NORTHSIDE INDEPENDENT SCHOOL DISTRICT

ADDENDUM No. 3

PROJECT NAME: **PAVING AND DRAINAGE UPGRADES AT MEADOW VILLAGE ES**

RFCSP# **2025-027**

PROPOSED SITE/GRADING PLAN AREA "G"

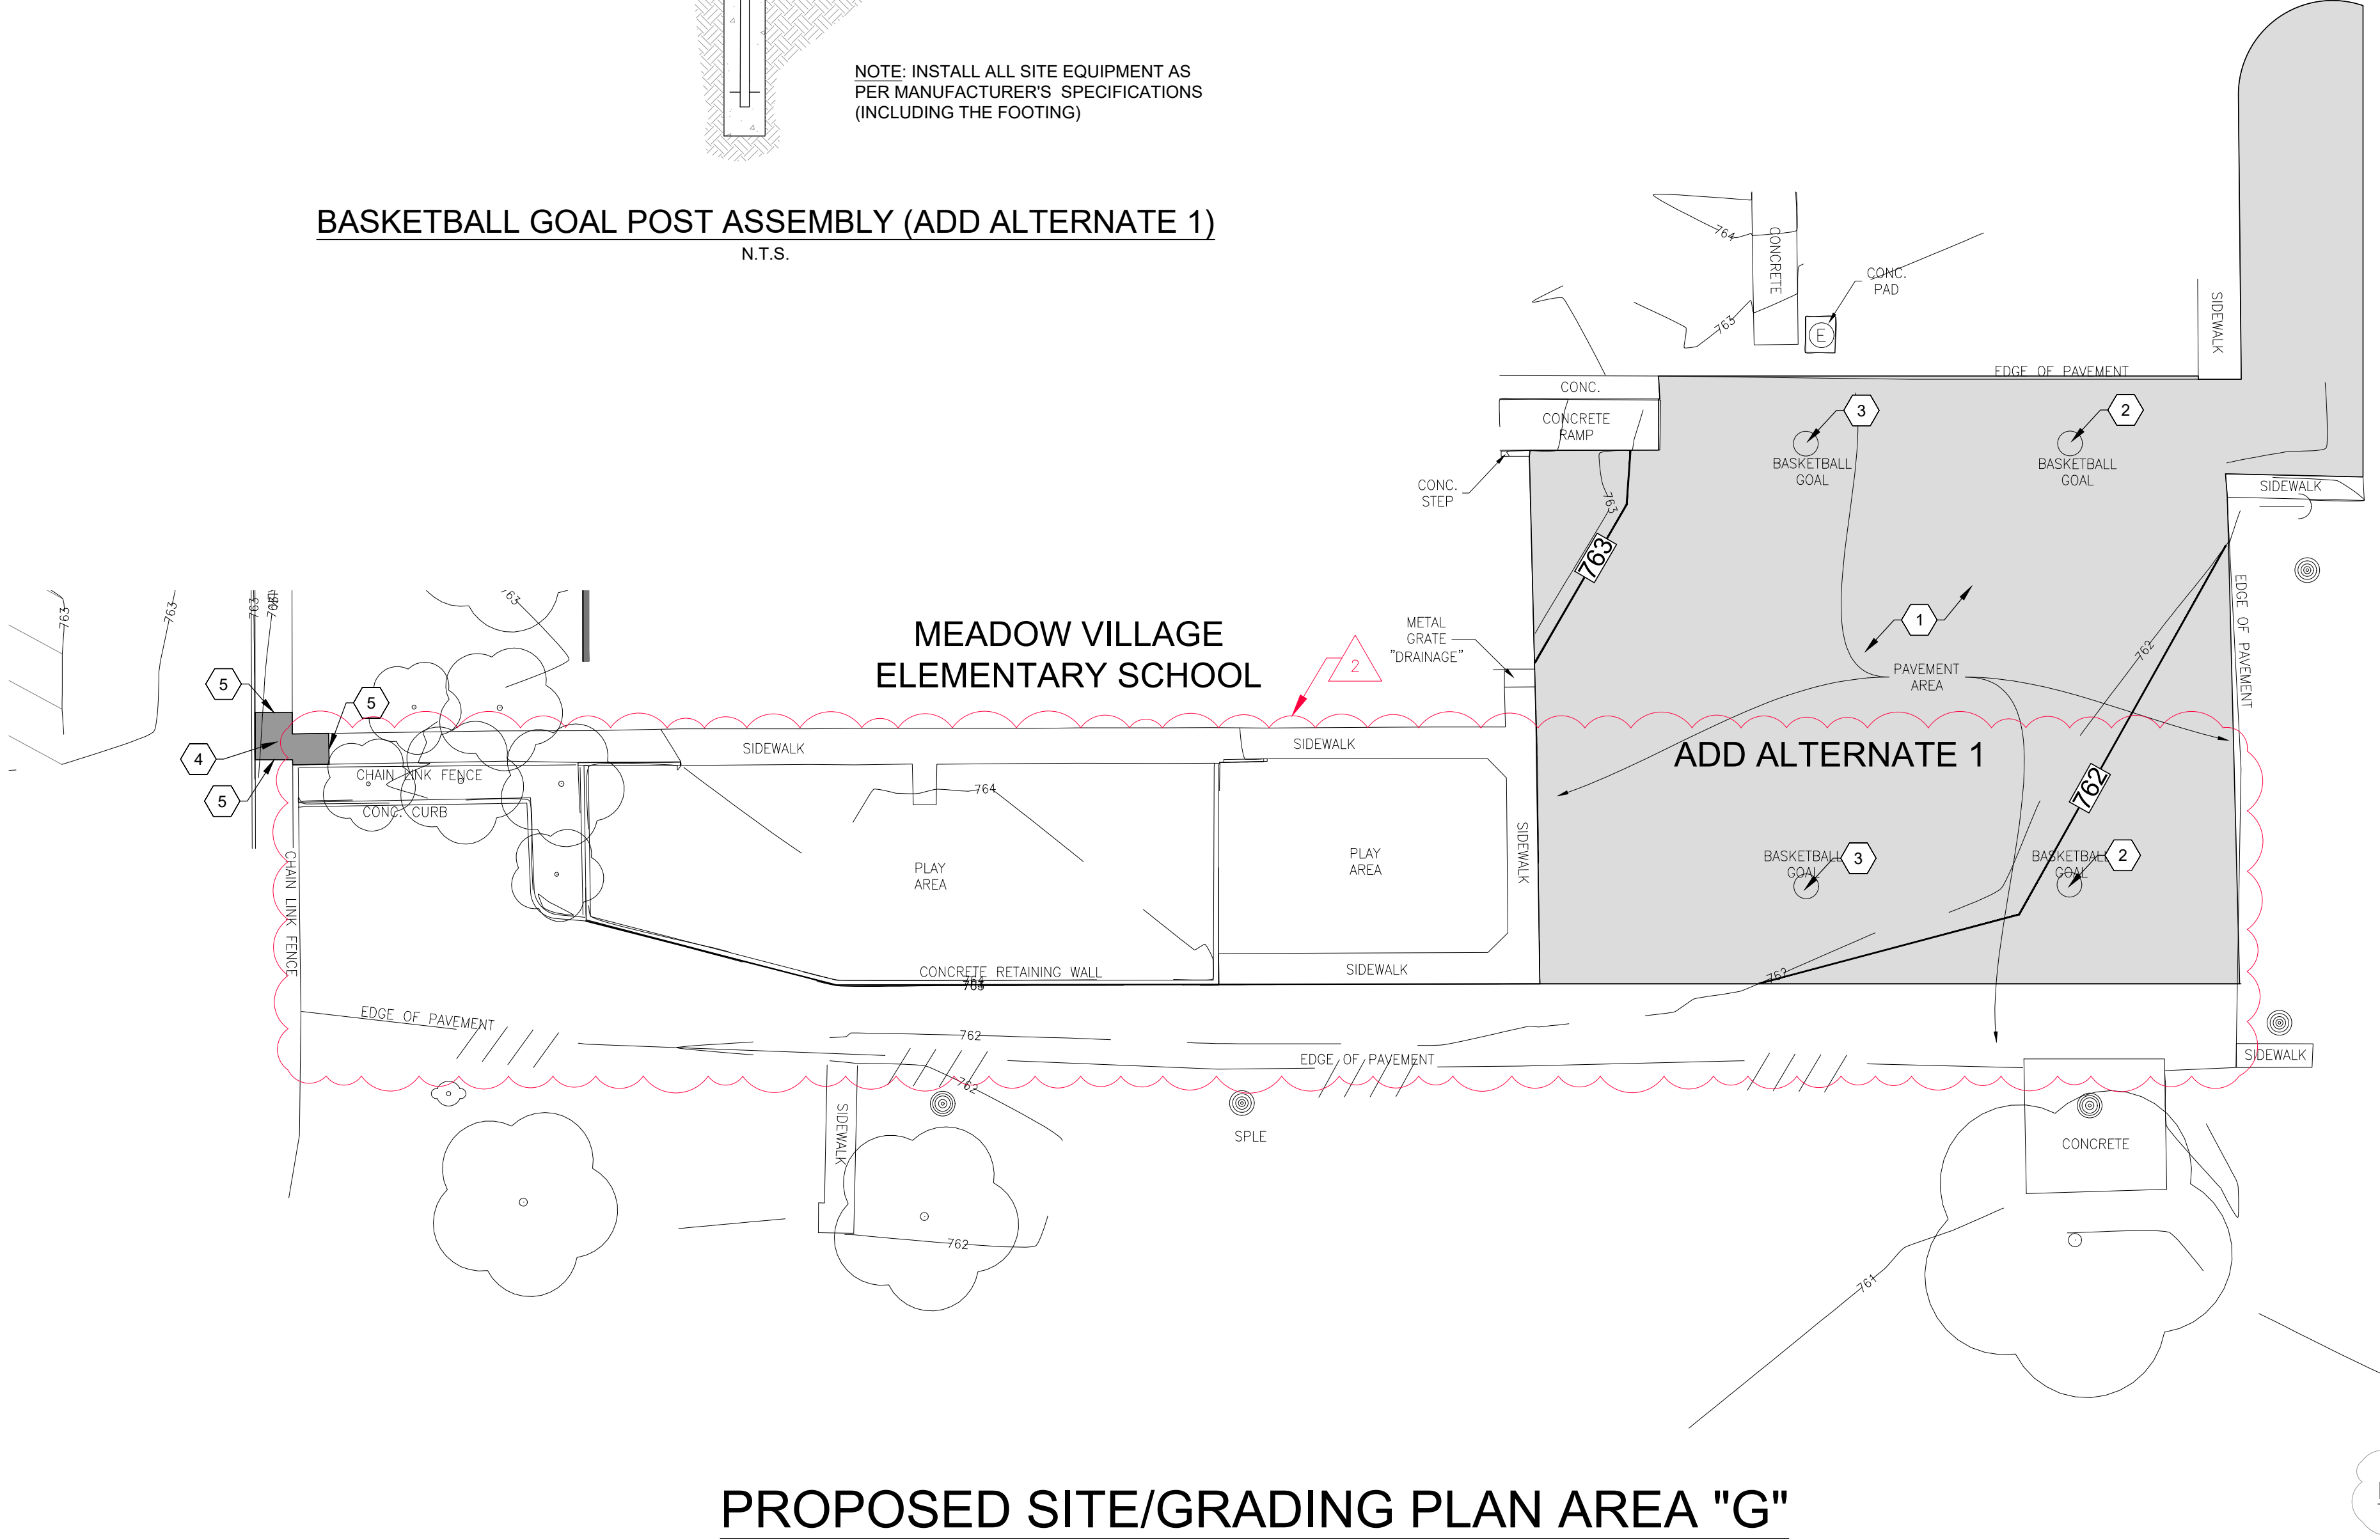
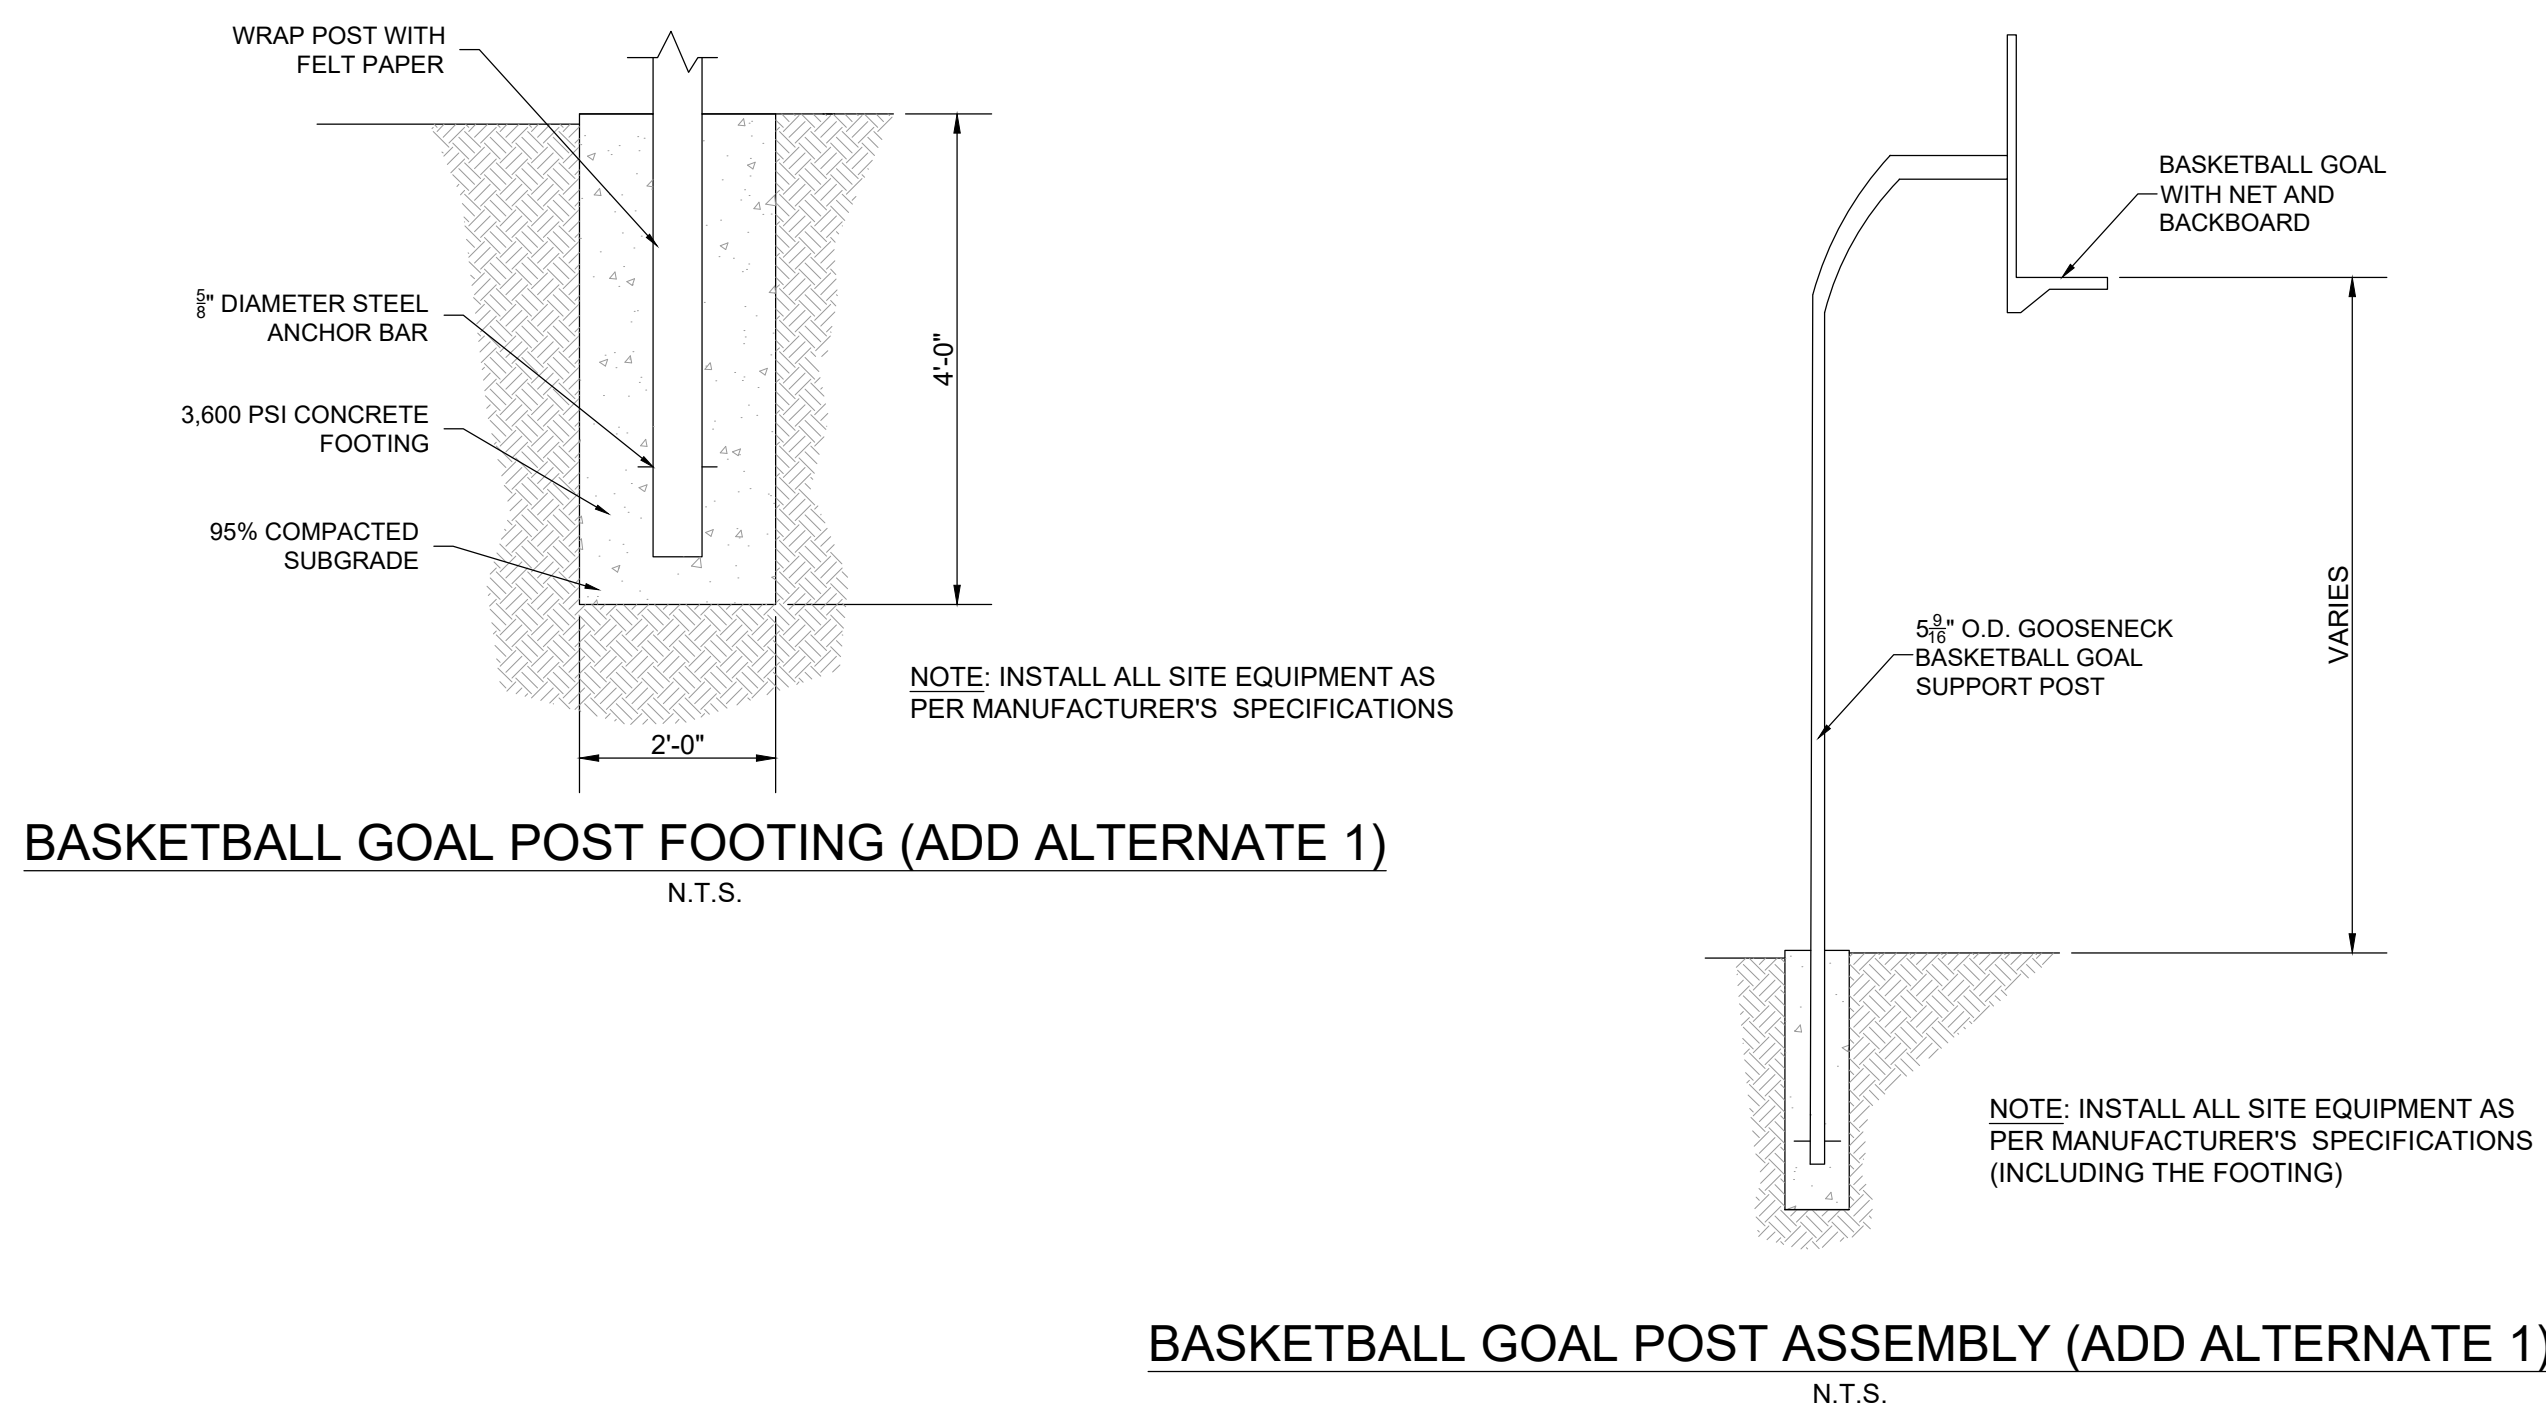
1. Addendum No. 2 sheet 13 of 15 Area "G" the title "Add Alternate No. 1" has been removed. If not, is the whole area "G" alternate No 1?

1. Sheet 13 OF 15 Proposed Site/Grading Plan Area "G": Sheet has been updated to remove scope of work, and add alternate 1 is identified.

Response: Sheet has been updated to remove scope of work, and add alternate 1 is identified.
